## APPENDICES

## **APPENDIX B: CONCEPTS AND COMMENTS**

Noteworthy Stakeholder and Public Comments

PROJECT INFORMATION		BASIS OF ESTIMATE	
Project Name:	Route 20 Shared Use Path Study		Code B - Preliminary Design
Project ID:	East Alternative		Pre-Final (Awaiting Final Coordination)
Location:	Albemarle County		Code C - Final Design
Date Prepared:	9/15/2023	30%	Custom Contingency Value

Figure 2: Possible extension of SUP into City, East Alternative

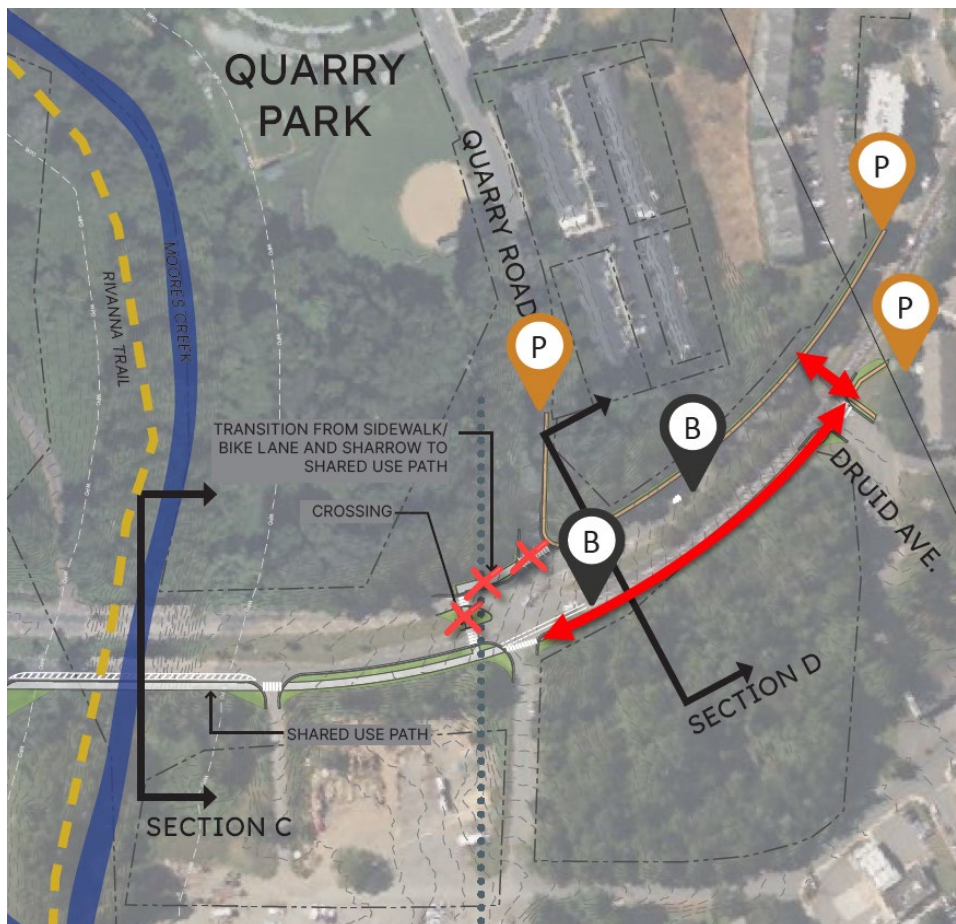
**Public Comment from CAC meeting:** Extend the SUP to the Druid Avenue intersection and provide a crossing there instead of at Quarry Road. The crossing at Quarry Road will be dangerous due to limited sight distances and speeding trends through that intersection.

Extending the SUP along the East edge of the road would not be difficult and would be an improvement to the East Alternative. Extending the SUP in the West Alternative would likely require some retaining along the steep slope adjacent to the road, but should be possible. It is critical to note that a crossing of Route 20 must occur in this vicinity to connect the proposed shared use path to the existing pedestrian and bicycle facilities which appear on both sides of the road. Due to the presence of Quarry Park as a pedestrian generator, pedestrian desire paths and volumes may warrant the crossing to be marked at Quarry Road. If this is the case, it is not recommended to mark a crossing at Druid Avenue, due to the proximity of the two intersections. A mid-block crossing study should be performed for both locations at the preliminary engineering stage to determine which location is the most appropriate for the needed crossing, and should consider roadway slope, desire paths, specific locations of pedestrian generators, sight lines, accident history, and traffic volumes (see VDOT IIM-TE-384.1).

A note on the mid-block crossing in this area: Any marked crossing will require a mid-block crossing study to be approved by VDOT, as the approaches along Route 20 at both intersections are uncontrolled. The current roadway was built for two lanes in both directions but has been striped to be one lane in each direction in this area. Any proposed improvement should provide curb extensions or bulb-outs to not only provide a shorter crossing distance, but also increase available sight distances and act as a traffic calming measure. This improvement appears feasible at either intersection. Lastly, it is notable that the limits of this study extend into the City several hundred feet, and both of these intersections are within City limits and will require coordination with the City to implement these improvements.

*Image D3: Crashes from I-64 Interchange to Hart Road.*

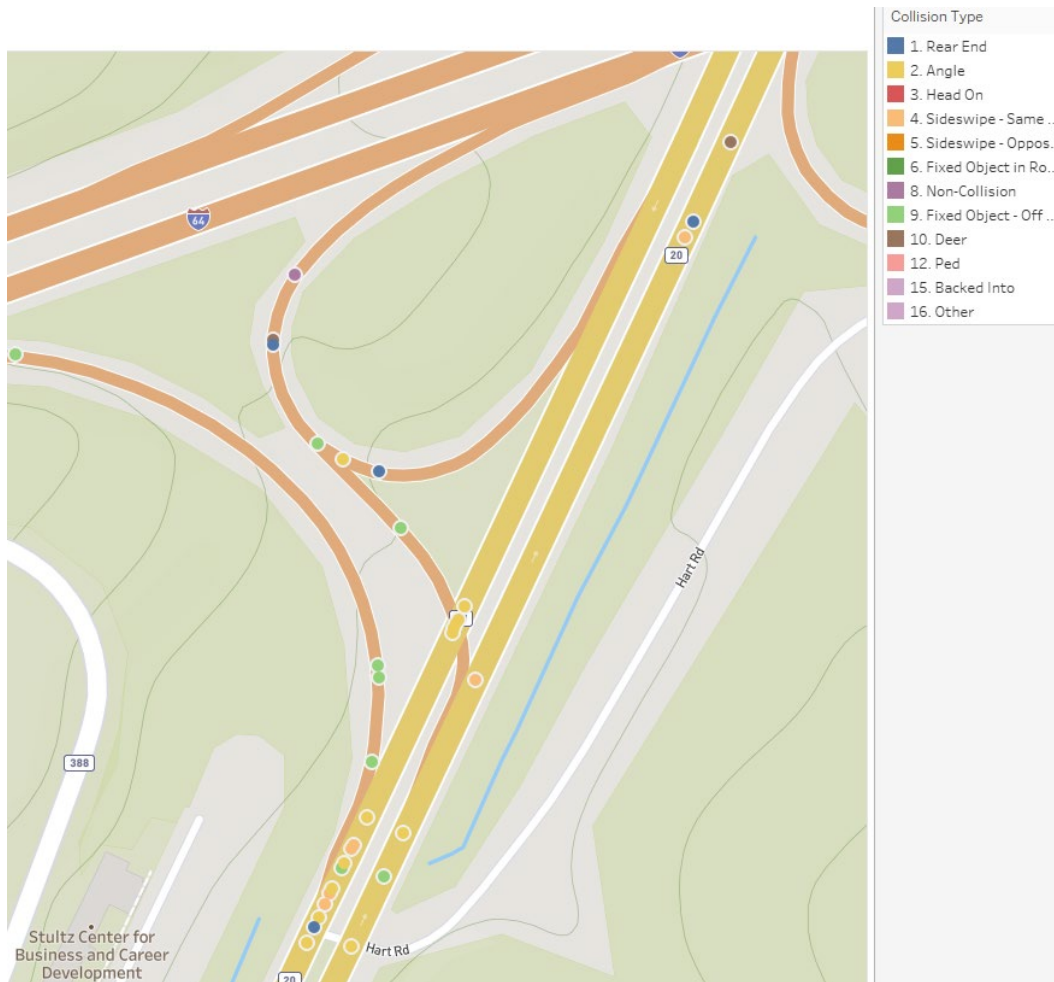
**VDOT Comment:** investigate eliminating the mid-block crossing and keeping the SUP on the west side of Route 20 until the proposed crossing at the PVCC entrance.

Note: crash rates in this vicinity justify a mid-block crossing in the West Alternative as opposed to the suggestion proposed by VDOT in which the path would continue along the western edge to the PVCC intersection.
